Report: TAB Report
Function: Test, Adjust, & Balance
Date: 01/18/2026
Completed By: National TAB

Fieldstone @ Chester Springs ALF (Chester Springs, PA)

Included in the following report is a TAB evaluation for an Energy Recovery Unit servicing the Fieldstone Assisted living facility in Chester PA. An original TAB Report was provided with altered design CFMs for specific terminal devices that dropped the design supply CFM of the ERU to 6210 CFM and dropped the Exhaust rate of the ERU down to 4800CFM. It should be noted that the ERU is occupied 100% of the time and that the exhaust air stream cannot mix as return air with the supply stream since exhaust is pulled from restrooms through the facility. Original unit programming seemed incorrect for this application.

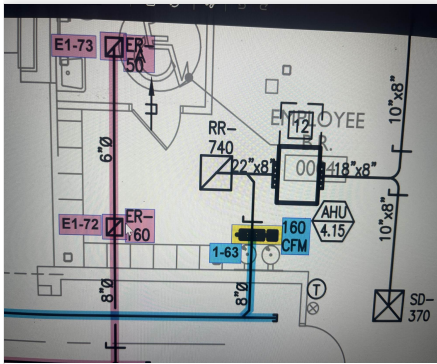
Issue Name : Basement exhaust fire damper
Description : There is a drop off in flow from the first floor exhaust duct down to the basement, branch dampers on the first floor and basement confirmed full open. The fire damper was inspected and confirmed fully open, but there is audible turbulence and the damper is internal to the duct and looks to be taking up 35-40% of the duct flow area.
Created By : National TAB **Assigned To :** National TAB - Tyler Youells
Status : Open
Priority : High **Asset Tag :**
Originated Date : 01/28/2026 - Tyler Youells - National TAB

- **01/28/2026 National TAB - Tyler Youells**
 - Suspect the fire damper is the cause of low exhaust flow on the first floor and recommend upsizing damper size.

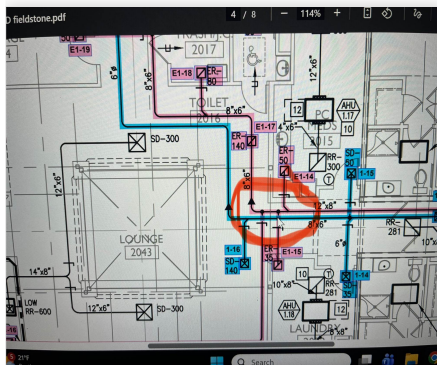
Issue Name : Locker room exhaust E1-72
Description : Exhaust register E 1-72 serving the locker room is installed as a 6" neck for 160CFM, Basement exhaust is already low but this exhaust register is at 22cfm. recommend upsizing the duct to 8" to allow for more flow.
Created By : National TAB **Assigned To :** National TAB - Tyler Youells
Status : Open
Priority : Medium **Asset Tag :**
Originated Date : 01/28/2026 - Tyler Youells - National TAB

PARTIAL SECOND FLOOR PLAN - MECHANICAL
 SCALE: 1/8"=1'-0"

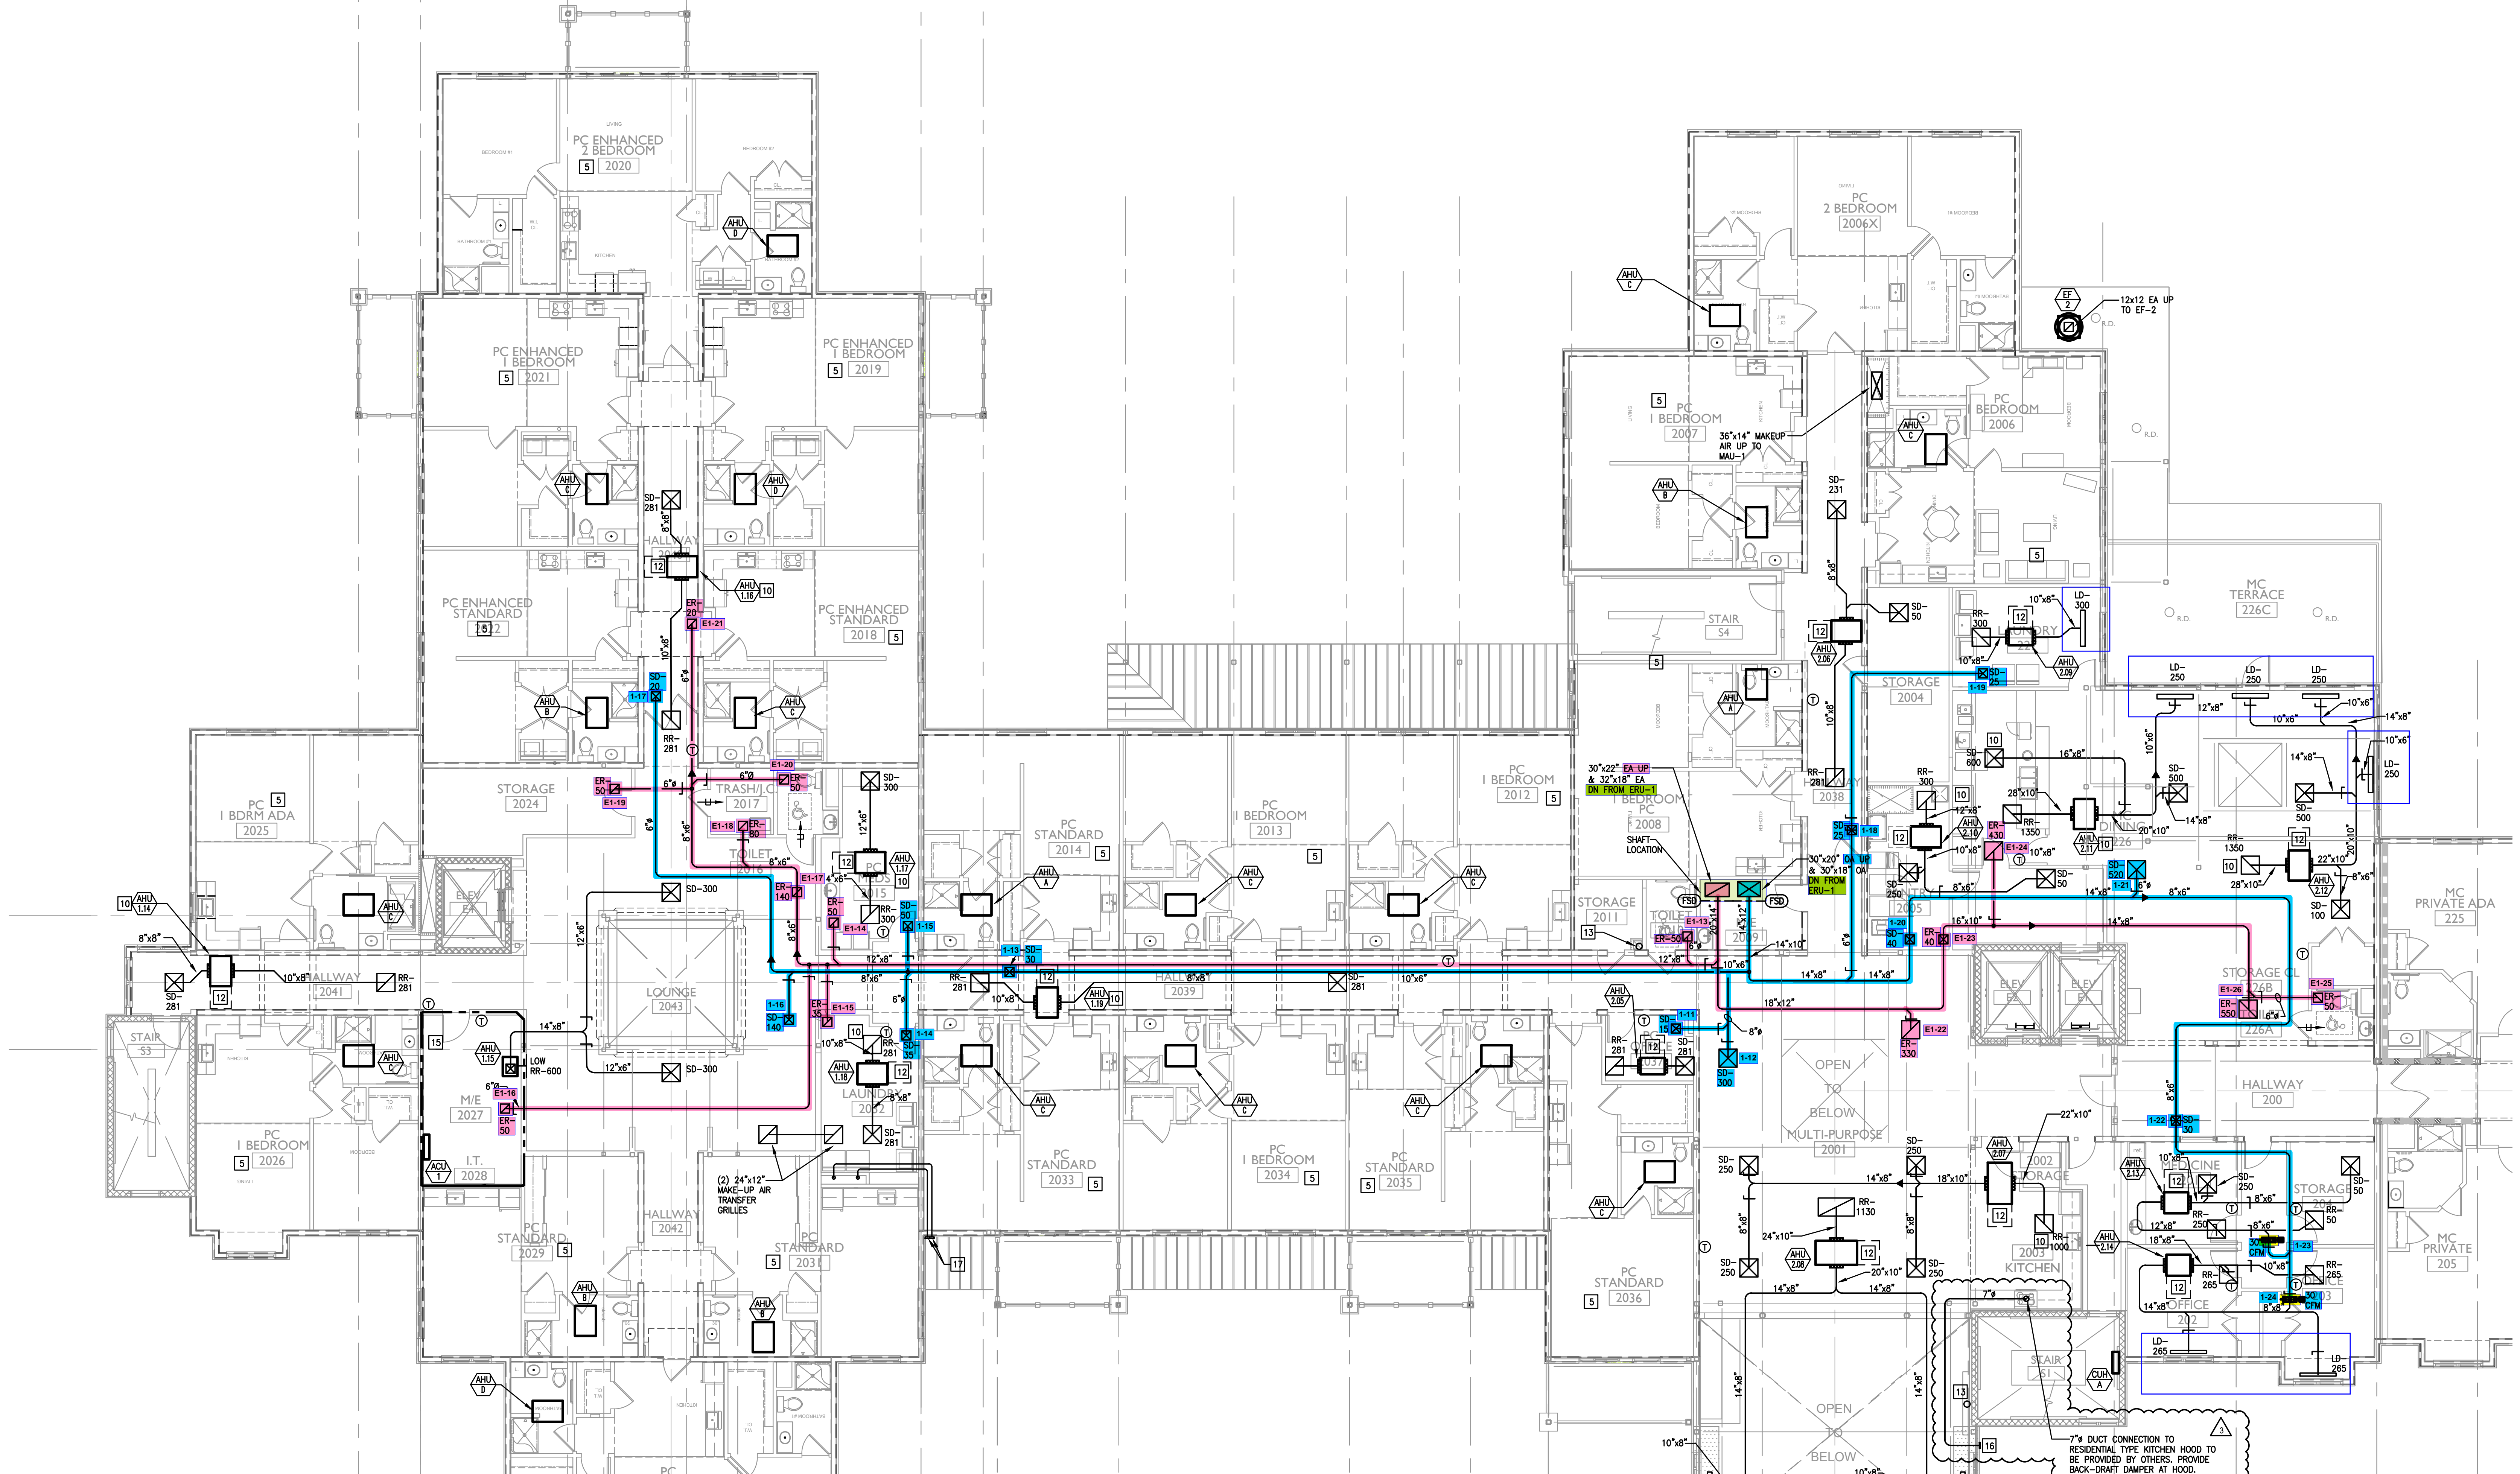
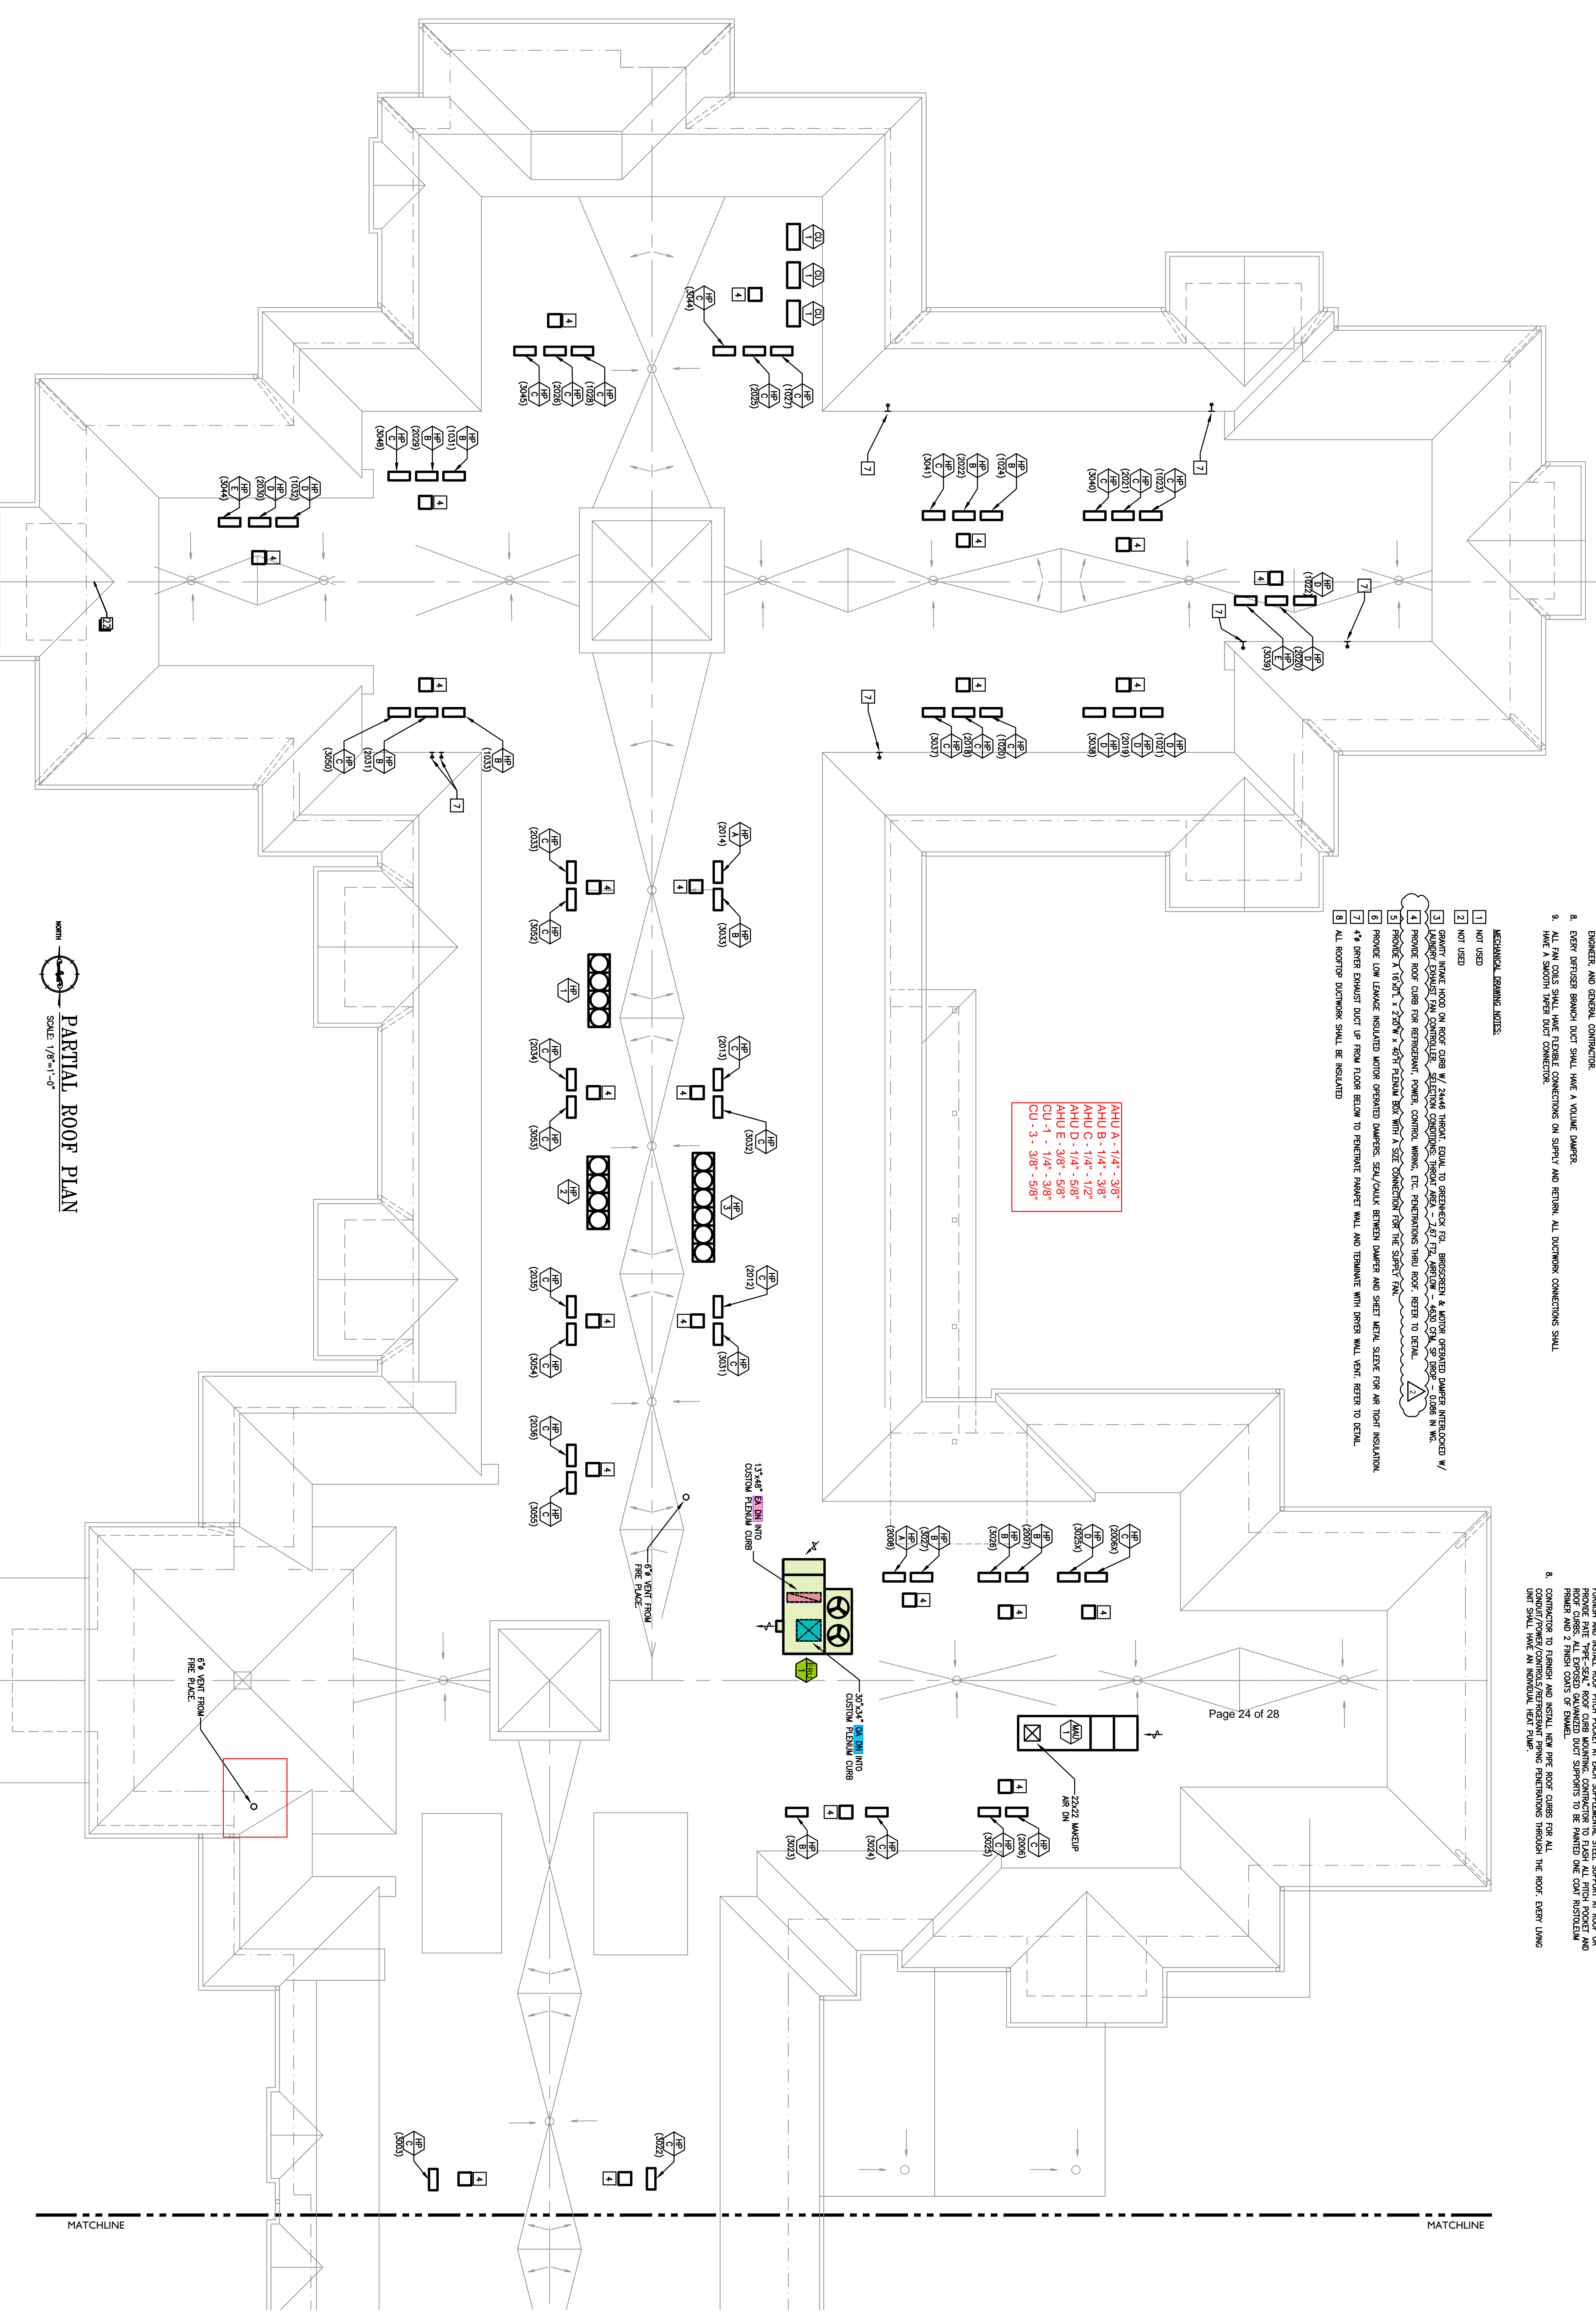
Issue Name : Second floor Exhaust duct
Description : Towards the end of the exhaust run on the second floor, a 12x8 to 6x8 transitioned occurred too soon causing 2-3 additional hits off the 6x8 duct where it should have been 12x8. the additional cfm load through the 6x8" duct is causing diffusers to be low on flow (E1-16 through E1-20)
Created By : National TAB **Assigned To :** National TAB - Tyler Youells
Status : Open
Priority : Medium **Asset Tag :**
Originated Date : 01/28/2026 - Tyler Youells - National TAB
